TITLE SCALE
205 SKIDTUBE ASSEMBLY NTS

DRAWING NO. D2580	TITLE 205 SKIDTUBE ASSEMBLY	REV. E	DART AEROSPACE LTD ENGINEERING ORDER	D.E.O. NO. D2580-E-1	SHEET NO. SHEET 1 OF 1	SCALE NTS
DRAWN <i>UP</i>	CHECKED <i>ASS</i>	MFG. APPR. <i>ER</i>	APPROVED <i>[Signature]</i>	DE APPR. <i>[Signature]</i>		
DATE 11.12.13	DATE 11.12.13	DATE 11.12.13	DATE 11.12.13	DATE 11.12.13

PURPOSE:

CHANGE ALL C'BORED WELDED CROSSBOLT SPACERS TO SWAGED SPACERS

SECTION B-B
SCALE 5X

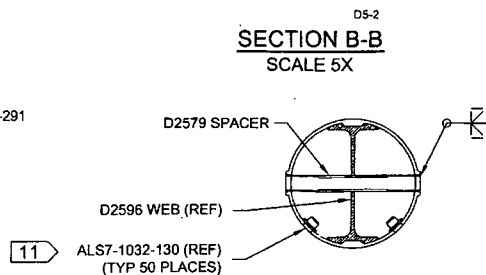
- AFTER DRILLING AND BENDING ASSEMBLY
PERFORM THE FOLLOWING FOR Ø0.508 HOLES ONLY:
1. CHAMFER HOLE 0.050 X 45°
 2. INSERT D2579 SPACER (20 PLACES)
 3. WELD INTO PLACE AND GRIND FLUSH
 4. C'BORE D2579 SPACER TO Ø0.437 X 1.00 DEEP

1. INSERT D4202-1 SPACER, 20 PL (-041) OR 20 PL (-045) OR 25 PL (-047)
2. SWAGE TO Ø0.437 X 1.00 DEEP PER QSI 002
3. TRIM / GRIND FLUSH PER QSI 002

SECTION I-I D5-7
SCALE 5X

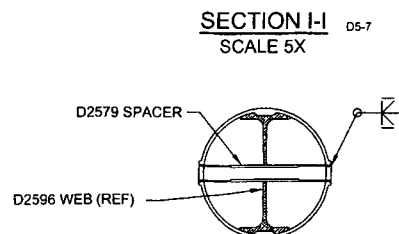
- AFTER DRILLING AND BENDING ASSEMBLY
PERFORM THE FOLLOWING FOR Ø0.508 HOLES ONLY:
1. CHAMFER HOLE 0.050 X 45°
 2. INSERT D2579 SPACER (25 PLACES)
 3. WELD INTO PLACE AND GRIND FLUSH
 4. C'BORE D2579 SPACER TO Ø0.437 X 1.00 DEEP

SECTION B-B, F-F, I-I
NOT TO SCALE

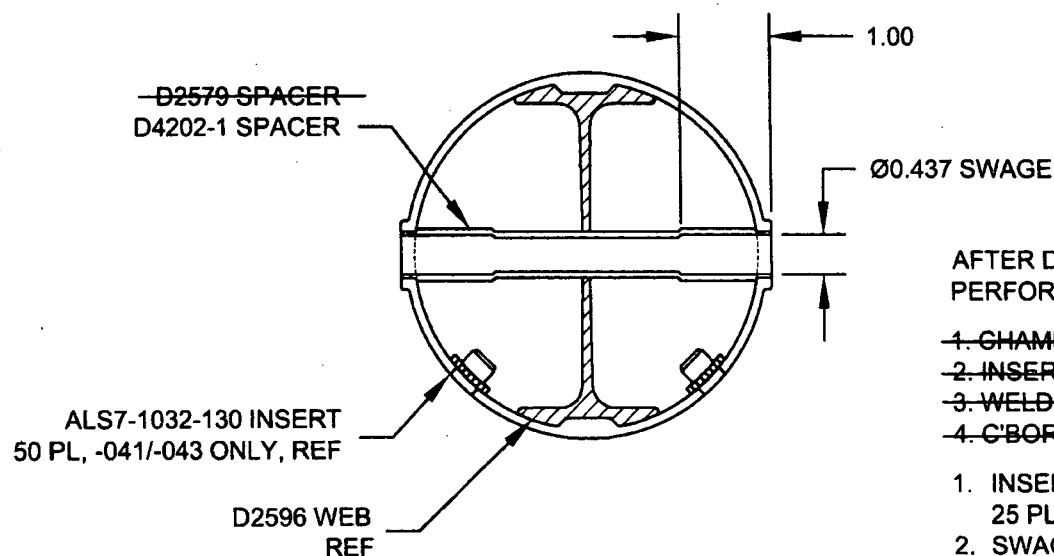
SECTION B-B, SECTION F-F, & SECTION I-I ARE AMENDED AS FOLLOWS
FOR ALL HOLES THAT WERE ORIGINALLY C'BORED:

AFTER DRILLING AND BENDING ASSEMBLY
PERFORM THE FOLLOWING FOR Ø0.508 HOLES ONLY:

- ~~1. CHAMFER HOLE 0.050 X 45°~~
- ~~2. INSERT D2579 SPACER (20 PLACES)~~
- ~~3. WELD INTO PLACE AND GRIND FLUSH~~
- ~~4. C'BORE D2579 SPACER TO Ø0.437 X 1.00 DEEP~~
